Shearwater Teric Firmware v16 Release Notes

VERSION 16 2019.05.27

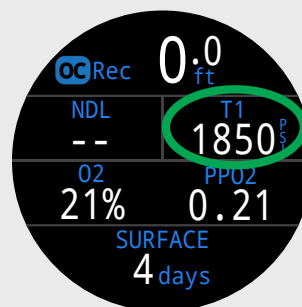
IMPROVE In the OC Rec Standard layout the TTS (top-right) location can be replaced by alternate displays.
